AGENDA FOR THE CANTERBURY BANKSTOWN LOCAL PLANNING PANEL MEETING

5 November 2018 - 6.00pm

ITEM 1	154 Hector Street, Chester Hill
	Conversion of existing unauthorised outbuilding to a secondary dwelling
FILE	DA-655/2018 – Bass Hill
ZONING	R2 Low Density Residential
DATE OF LODGEMENT	21 August 2018
APPLICANT	Thi My Dung Doan
OWNERS	Thi My Dung Doan
ESTIMATED VALUE	\$60,000.00
AUTHOR	Planning

ITEM 2 **Application to amend Canterbury Local Environmental Plan 2012: 194-198 Lakemba Street, Lakemba and 56-57 Railway Parade, Lakemba**

Figure 9. Proposed Development Scheme in existing context

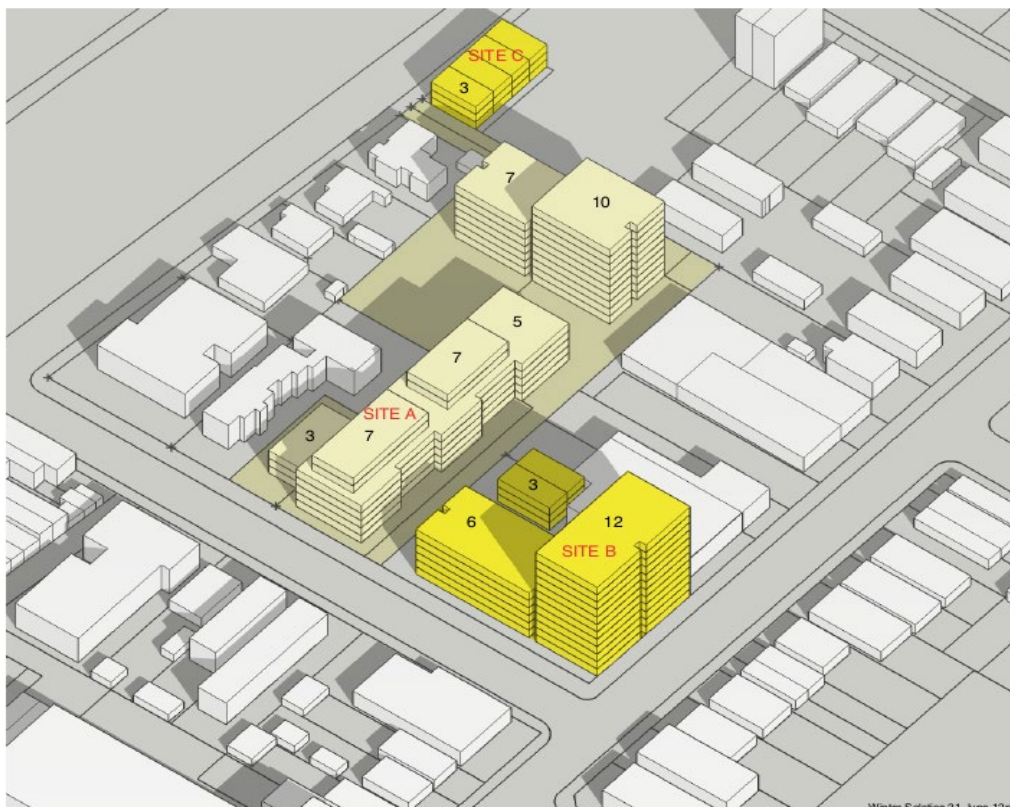
Of particular concern, the proposal appears to include a street wall height of 40m built to the property boundary for a width of 34m on Lakemba Street (Figure 9) and a built form length of 53m on Lakemba Street without any proper articulation or upper level setback which will contribute to the perception of its bulk and scale.

The proposal also includes a 12m separation distance fully within the adjacent lot on the western side of the site which does not comply with the ADG requirement to provide at least 50% of the required separation distance within the subject site and will also limit potential future development potential of this property.

Wall Height

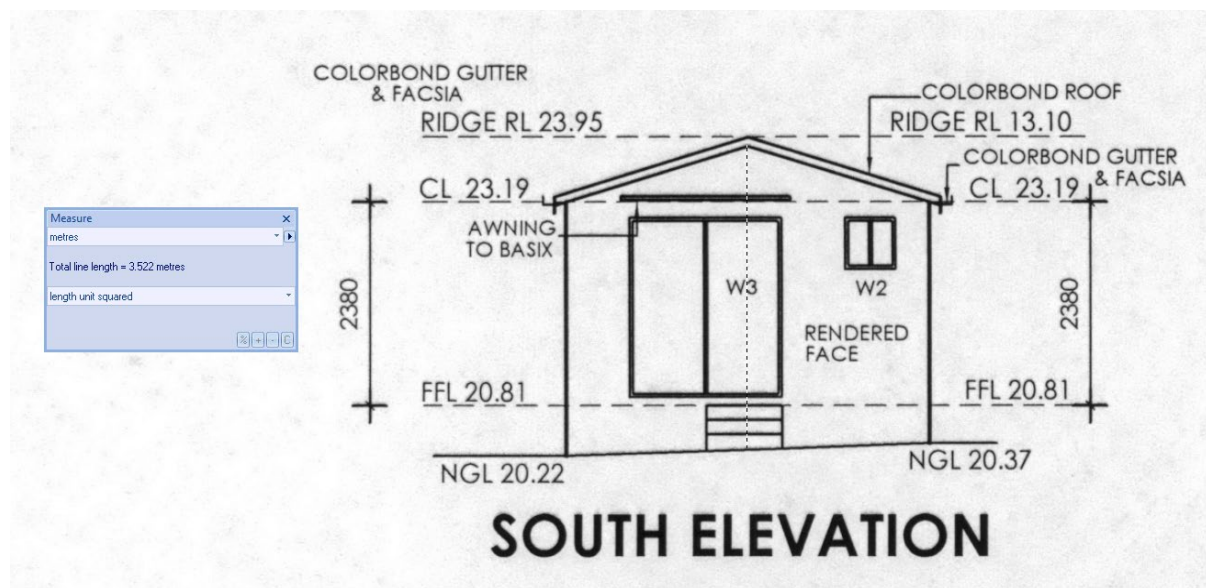
Clause 3.4 of Part B1 of the BDCP 2015 requires the secondary dwelling to have a maximum wall height of 3m. The wall height of the proposed secondary dwelling measures at 3.5m, causing a non-compliance of 0.5m above the maximum allowable wall height of 3m. The non-compliance arises due to the nature of the roof form / gable end wall found on the southern (rear) elevation.

It is considered that enforcing compliance with the abovementioned clause in relation to wall height would be unreasonable. The wall height control is like for like in terms of wall height for secondary dwellings and outbuildings, from which in this case the wall height for the existing outbuilding displays an existing non-compliance.
